MIL "ON" DTC P219A or P219B (2GR-FE)

Service Category Engine/Hybrid System

Section Engine Control

YEAR(S)	MODEL(S)	ADDITIONAL INFORMATION
2012 – 2013	Camry	
2012	Venza

Figure 1. Location of Authorized Modifications Label on 2012 – 2013 Camry

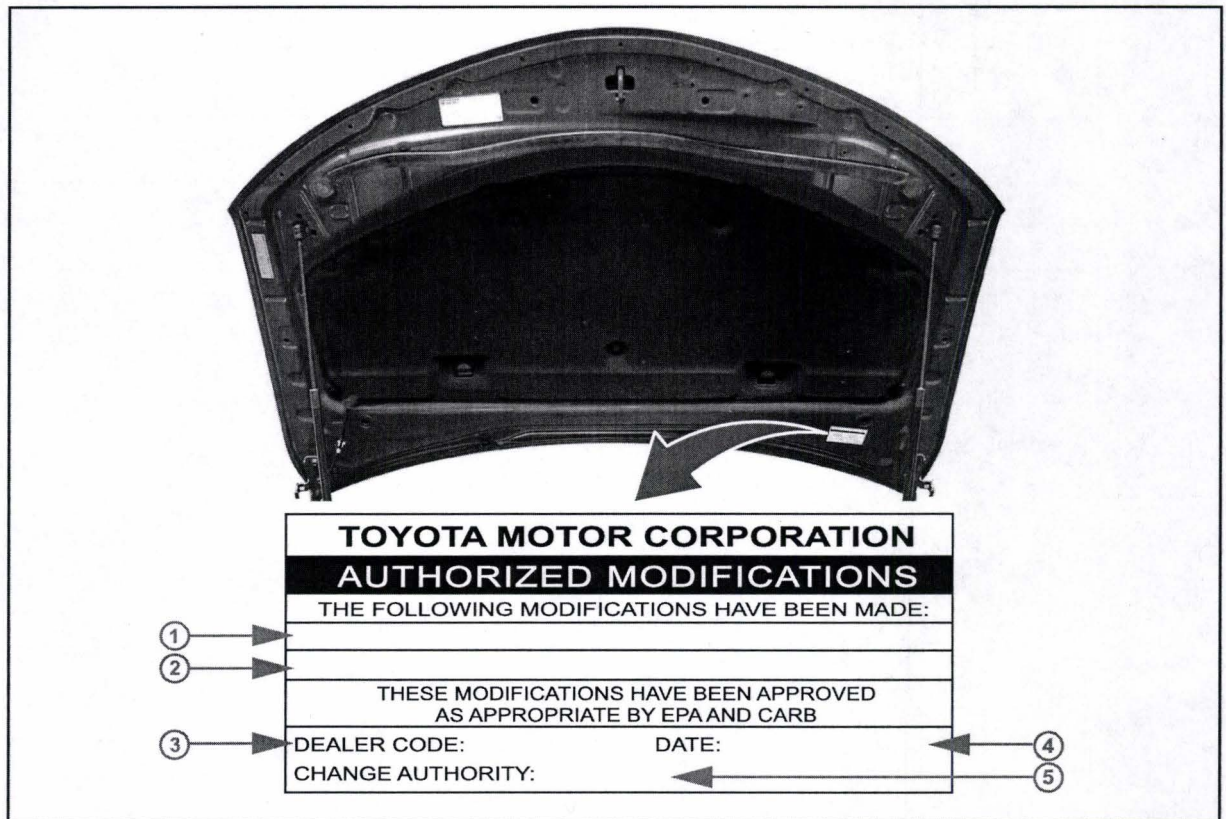
2. Check for the Authorized Modifications Label affixed to the vehicle in the location shown in Figures 1 and 2. Confirm if the ECM (PCM) calibration has been updated. If the calibration ID listed is NOT the latest ECM (PCM) calibration — go to step 3.

4. Install the Authorized Modifications Label.
 - A. Using a permanent marker, enter the following information on the label:
 - ECM part number [Refer to the **Parts Information** section for the **CURRENT PART NUMBER**]
 - Calibration ID(s) [Refer to the **Calibration Identification Chart** for the **NEW CALIBRATION ID**]
 - Dealer Code
 - Repair Date
 - Change Authority [**This bulletin number**]
 - B. Affix the Authorized Modifications Label to the vehicle at the location shown in Figures 1 and 2. The Authorized Modifications Label is available through the MDC, P/N 00451-00001-LBL.
5. Test drive the vehicle to confirm proper vehicle operation.
